Access Compliance Report Public Rights-of-Way (Curb Ramps)

Main Street: SANDUSKY_LN	Cross Street: MCFADDEN_AVE	Location: SW
--------------------------	----------------------------	--------------

ADA ID: RPRK210930114358	Ramp Type: Type 1 - Perpendicular Diagonal Initial Pass/Fail: Fail	Overall Compliance: No	Severity Score: 2
--------------------------	--	------------------------	-------------------

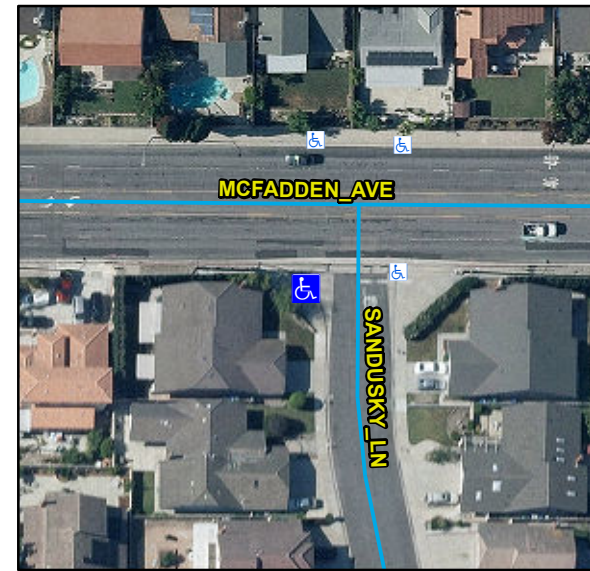
R304.2.2, R304.5.3, STD 1115

Compliance	Description	Data	Compliance	Description	Data
N/A	Ramp Length (in)	110	N/A	Flare Type LT	
Yes	Ramp Width (in)	48			N/A
Yes	Ramp Run Slope (%)	6.9	N/A	Flare Slope LT (%)	N/A
No	Ramp Cross Slope (%)	3.3	N/A	Flare Traversable LT	N/A
N/A	Landing Present	N/A	N/A	Flare Type RT	
N/A	Landing Length (in)	N/A			N/A
N/A	Landing Width (in)	N/A	N/A	Flare Slope RT (%)	N/A
N/A	Landing Run Slope (%)	N/A	N/A	Flare Traversable RT	N/A
N/A	Landing Cross Slope (%)	N/A	N/A	DWS Provided	N/A
N/A	Landing Movement Obstructed?	N/A	N/A	DWS Contrast	N/A
	Landing Movement Type	N/A	N/A	DWS Length (in)	N/A
N/A	Landing Shared	N/A	N/A	DWS Full Width	N/A
N/A	Clear Space	Yes	N/A	DWS Offset Left (in)	N/A
N/A	Clear Space To Crosswalk (in)	N/A	N/A	DWS Offset Right (in)	N/A
N/A	Marked Crosswalk 1	No	N/A	Marked Crosswalk 2	No
	Crossing 1 Direction	E		Crossing 2 Direction	N
	Marked Crosswalk 1 Width (in)	N/A		Marked Crosswalk 2 Width (in)	N/A

Remove & Replace Curb Ramp With Two New Directional Ramps or Equivalent.
